CAMECO RESOURCES
*Smith Ranch-Highland
Operation*
Mail:
P.O. Box 1210
Glenrock, WY
82637 USA

RE: Replacement Monitoring Well KM-15A, Cameco Resources, Smith Ranch Highland
Uranium Project, Permit 633

INDEX SHEET FOR MINE PERMIT AMENDMENTS OR REVISIONS

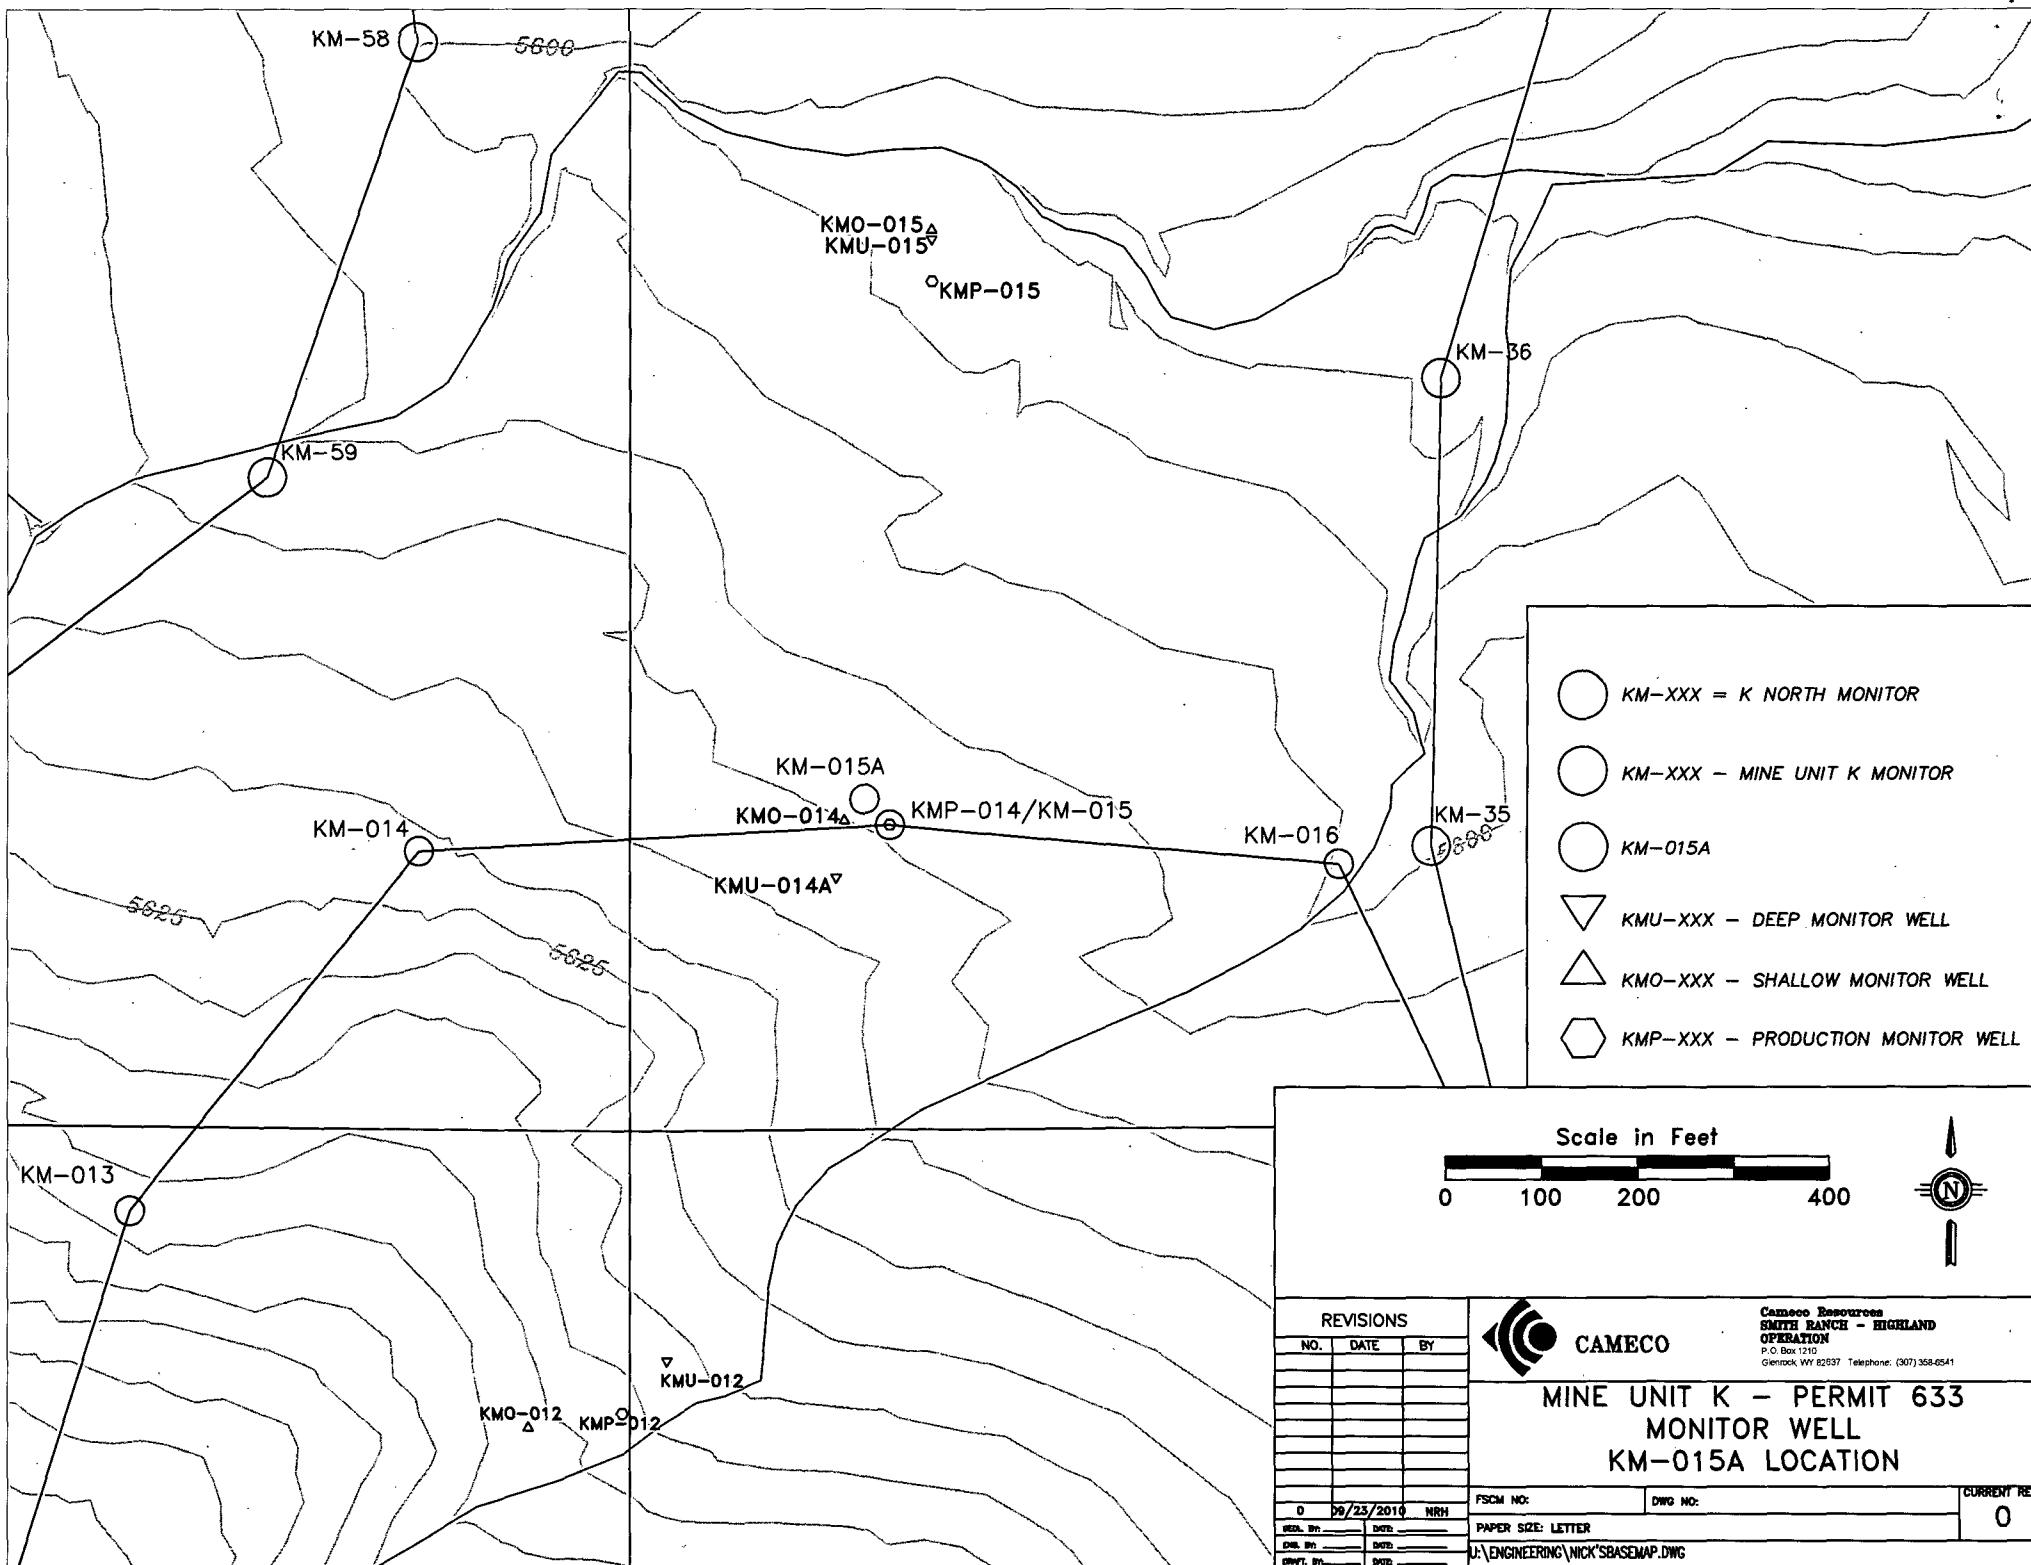
Volume Number	Page, Map or other Permit Entry to be REMOVED	Page, Map or other Permit Entry to be ADDED	Description of Change
Volume III-K	Page 7	Page 7 and Attached Map	Replacement page provides discussion of wells KM-15A and KMP-14. The attached map labeled <i>Mine Unit K – Permit 633 Monitor Well KM-015A Location</i> illustrates where the discussed wells are found in the wellfield. The attached map should follow right behind page 7.
Volume III-K		1 Completion/Recompletion Report for monitoring well	Add well completion report for well KM-15A to the Hydrologic Test Plan for Mine Unit K. The report should be placed behind the Appendix B "Completion Report" cover page.
Volume III-K		1 Completion/Recompletion Report for production monitoring well	Add well completion report for well KMP-14 to the Hydrologic Test Plan for Mine Unit K. The report should be placed right behind the new well completion report for KM-15A discussed above.

WELL NUMBER	KM-015A	DATE	9/8/2010
HDR_HSE	HH	CONTRACTOR	SINGLE WATER SERVIC
HOLE_DIAMETER	8-3/4"	CAMECO REPRES.	Darryl Parrett
CASING_SIZE	5"		
REAMED_DIAMETER	8.875

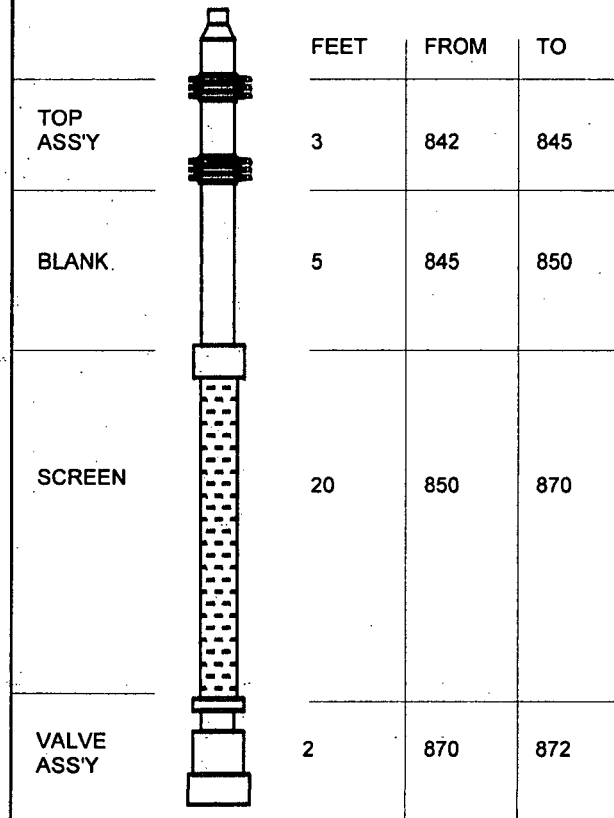
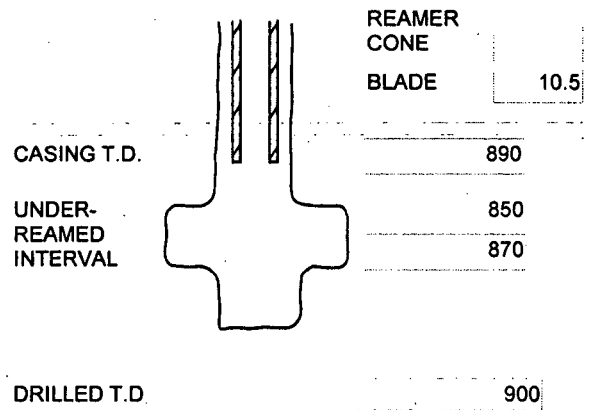
This well replaced KM-15 which became production monitoring well KMP-14
